# TIE-LINE 637 WOOD-TO-STEEL PROJECT MINOR PROJECT REFINEMENT REQUEST FORM

Date Requested:		May 2, 2014 <b>Report #:</b>		005		
Date Approved:		May 6, 2014		Approval Agency:		No other agency approval is required.
Property Owner(s):		SDG&E Right-of-Way (ROW)		Location/Milepost:		Stringing Site No. 4
Land Use/ Vegetative Cover:		The proposed in area occurs prim within non-nativ grassland.	narily	Sensitive Resources:		Cultural resources and sensitive habitats including non-native grassland.
Refinement /	Mod	ification From (	check all	that apply)	:	
Permit		Plan/Procedure	Spe	cification	Drawing	Mitigation Measure (MM)
Other: Strin	ging S	site Modification				
San Diego Gas & Electric Company (SDG&E) is proposing to utilize a different temporary workspace for Stringing Site No. 4 (SS-4), located near Structure No. P25 within Simon Preserve (County of San Diego), than the workspace area that was originally described within SDG&E's application for a Permit to Construct (PTC) for the TL 637 Project (refer to Proponent's Environmental Assessment [PEA] Appendix 3-B) and the Final Initial Study/ Mitigated Negative Declaration (IS/MND) (refer to MND Attachment A).

Figure 1: MPR Overview Map

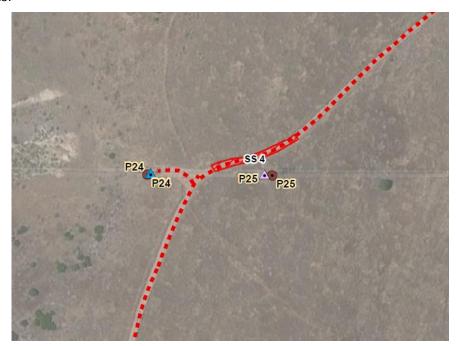
Description of	f Refi	nement				
SDG&E proposes to use a different temporary workspace for SS-4 near Structure No. P25 in order to safely and successfully conduct stringing activities. The proposed modification shifts the stringing site off of the existing access road and to the north, changes the shape, and reduces the workspace area required for stringing activities. The modified stringing site area is approximately 30 feet by 60 feet and will result in approximately 1,800 square feet of impacts to non-native grassland habitat. The original SS-4 temporary workspace area would have resulted in approximately 2,100 square feet (14 feet by 150 feet) of temporary impacts.  Figure 2 depicts the proposed new temporary workspace for SS-4 and the original SS-4 location within the existing access road. Photograph No. 1 depicts the proposed new temporary workspace area for SS-4.						
Original Condition:

SS-4 was originally planned to be located within a 14 foot by 150 foot area entirely within the existing access road adjacent to Structure No. P25 within Simon Preserve (refer to Figure 1).						
Justification for Change:						
Following in-field review of the stringing site, construction crews identified potential logistical and safety concerns with utilizing the originally planned temporary workspace for SS-4 (refer to Figure 1). The original location of SS-4 is located within the access road; and in order to maintain clear access roads in the event of an emergency as well as maintain an unobstructed aerial path to safely pull conductor the stringing site needs to be moved off the road. The modified SS-4 temporary workspace area is advantageous to using the existing SS-4 location because it is safer to use in the event of an emergency, the area is more conducive to the proposed work activities, and will result in less anticipated temporary impacts.

Disturbance Acreage Changes?					
Original Disturbance Acreage:  The previously contemplated temporary workspace area for SS-4 would have resulted in a disturbance area of approximately 2,100 square feet (150 feet long by 14 feet wide) adjacent to Structure No. P25 (refer to Figure 1).  New Disturbance Acreage:  The proposed new temporary workspace area for SS-4 is anticipated to result in a disturbance area of approximately 1,800 square feet (60 feet long by 30 feet wide) as shown in Figure 2. This would result in a reduction in disturbance area of approximately 300 square feet as a result of the proposed construction activities.
